Office Action Summary	Application No. 10/803,216	Applicant(s) BARTEL, A. GARY	
	Examiner Paul Devoti	Art Unit 3637

DETAILED ACTION

Darling (US 5531048) Figure 1

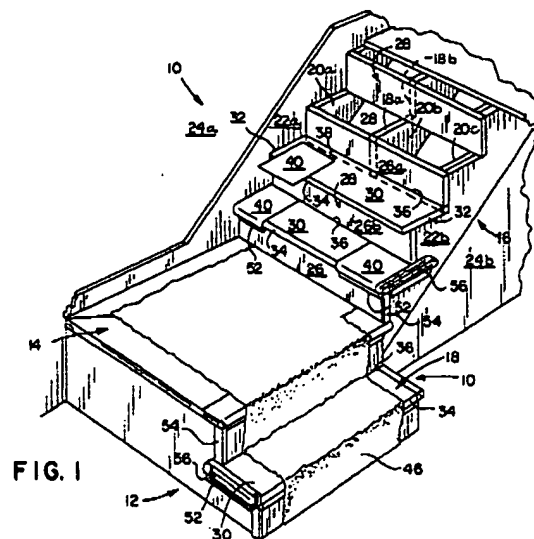
3. Claims 1-17 are rejected under 35 U.S.C. 103(a) as being unpatentable over Darling (US 5531048) in view of Lanphier (US 2004/0010987).
4. Regarding claims 1, 2, 4, 5, 8, 10, and 12, Darling discloses a stairway (10) with tread ends that simulate the appearance of an installed wood stair tread end, comprised of an upper section (54, improperly labeled as 56 in Figure 1) and lower section (52). The upper section (54) has inner and outer side edges and a front edge. The lower section (52) has a generally elongated rectangular section, and has a lateral extension less than the lateral extension of the upper section (54). Darling, however, does not disclose how the upper section and lower section are joined, where the rear surface of the upper section has a recess into which the lower section is disposed, or that the tread end edges are milled. Lanphier discloses a false tread module that may be machined (paragraph 0013) with an upper member (1, 2) having recess into which a lower member (4) fits. Therefore, it would have been obvious to one having ordinary skill in the art at the time of invention to modify Darling's stairway to include milled end caps with upper and lower members that are joined by the lower member fitting into a recess of the upper member, as taught by Lanphier to securely join the upper and lower members.

8. Regarding claims 11, Darling in view of Lanphier discloses everything previously mentioned, including a vertically disposed filler strip (56, improperly referenced as 54 in Figure 1) installed between the lower section of a tread end and the next lower tread end's upper section.

12. Regarding claim 17, Darling in view of Lanphier discloses everything previously mentioned, including the treads (30) and risers (26) of the stairway are covered with carpet (46).
